RE: Citrus County Solid Waste Management Department
Citrus County Central Landfill
Permit No. 21375-025-SO-01
Response to Warning Letter #WL20-207SW09SWD and Inspection Report

CITRUS COUNTY CENTRAL LANDFILL

RESPONSE TO FDEP

REGARDING ON-SITE INSPECTION

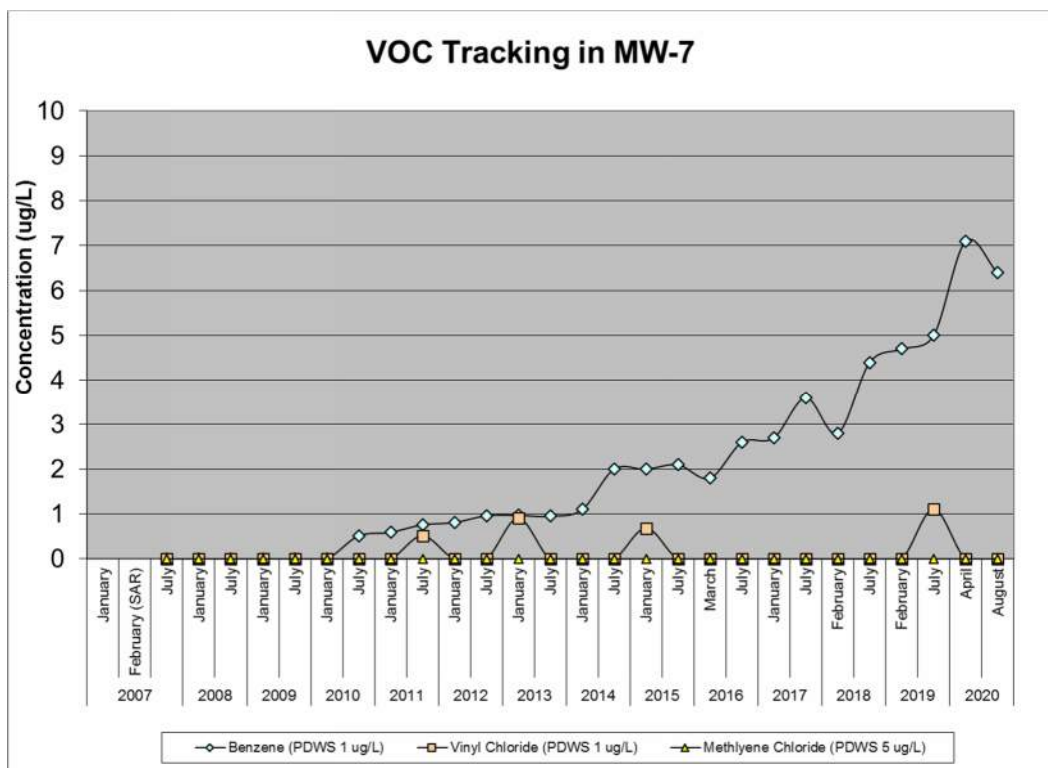
Explanation: A) Volatile Organic Compounds (VOCs) were detected above groundwater standards at monitoring wells (MW) 7 and 19 in the groundwater monitoring reports for events submitted between the second semiannual 2016 and second semiannual 2020 reports. The first semiannual 2016 groundwater monitoring report attributed the vocs exceedances at these wells to landfill gas. Arsenic was also detected above groundwater standards at MW-7 and MW-20. The Arsenic exceedances in MW-20 were first reported with the first semiannual 2020 groundwater monitoring report, but the Arsenic exceedance in MW-7 was just reported with the second semiannual 2020 groundwater monitoring report.

Corrective Action: A) Per the second semiannual 2020 groundwater monitoring report, the new landfill gas system has been in operation full-time since June 2020. Per the monitoring data provided with this report, the concentration of Benzene within MW-7 remains an exceedance (6.4 ug/L) while other vocs concentrations were detected below drinking water standards. The VOCs in MW-19 remain exceedances (Vinyl Chloride - 3.8 ug/L; Benzene 2.2 ug/L). It may be too soon to know the degree of effectiveness of this new landfill gas system until it has been in operation for at least one year. The blower system is also indicated to be working, but possibly not at the level desired. To maximize the efficiency of the landfill gas extraction system, increasing the frequency in which the gas wells are tuned, which is currently twice per year, should be completed to sufficiently capture the seasonal variations of gas production at this facility. Lastly, this semiannual report indicates that the plume of VOC exceedances in the area North of the Closed Landfill Cells has been delineated. A review of the data presented regarding this matter is still undergoing review by the Department.

We expected that the system would take some time to make an impact on the groundwater. We expected a year to start seeing improvements in the wells.

We observed a decrease in VOCs in MW-7 for the first time in over 2 years during the Second Semiannual 2020 sampling event. The decrease followed an increase during the First Semiannual 2020 event. The active LFG system started pulling LFG from around MW-7 at the beginning of 2020, whereas the LFG migration control system on the closed cells was not running until June 2020. The initial increase may be attributed to pulling more gas over near MW-7 followed by the initial decrease as we continued removing LFG and lowering the partial pressure on the groundwater in this area. Lowering the pressure drives the reaction back so that the VOCs stay in the gas and out of the groundwater. We expect these concentrations to continue to decrease as the system continues operation.

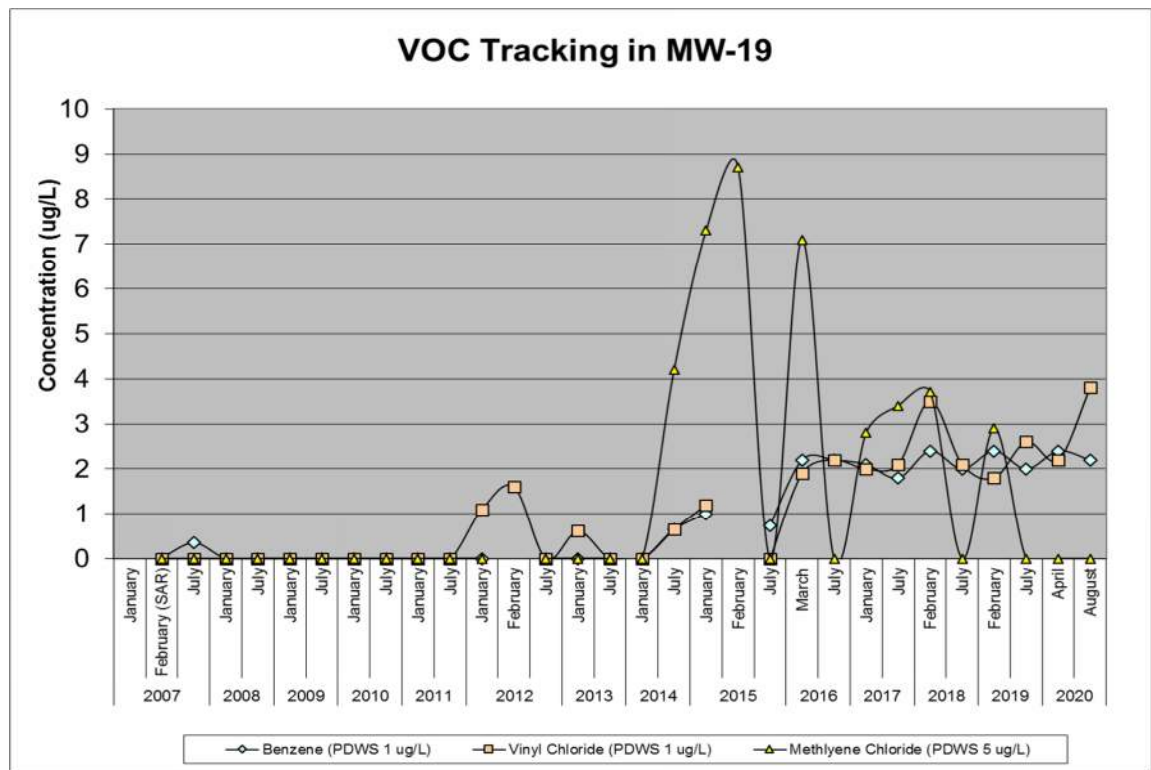
B) Discussion between the Department and facility personnel regarding MW-19's screen being submerged by groundwater occurred during the inspection. Because landfill gas does not typically migrate through water, the Department has concerns that there may be some type of conduit within the well that is permitting landfill gas to permeate into the well casing. Department personnel indicated that the facility could utilize a small submersible

B) Please provide the Department with information regarding any efforts taken to investigate MW-19 within 30 calendar days of the date listed on the attached letter.

In MW-19D, we observed a slight decrease in Benzene but an increase in Vinyl Chloride during the Second Semiannual 2020 sampling event. Methylene Chloride, the most volatile of the three parameters and being the quickest to partition in and out of the groundwater, has been below the laboratory detection limit since the First Semiannual 2019 sampling event.

In addition, as documented in the Second Semiannual 2020 Groundwater Monitoring Report, MW-19D is installed with a deeper screened interval clustered with MW-19 to monitor for vertical migration in this area. VOCs reported in MW-19D were all below the laboratory detection limit during this sampling event indicating limited vertical migration in this area. MW-18 and MW-18D are installed downgradient of the MW-19 well cluster and screened at similar intervals. No VOCs were detected in either of the MW-18 wells.
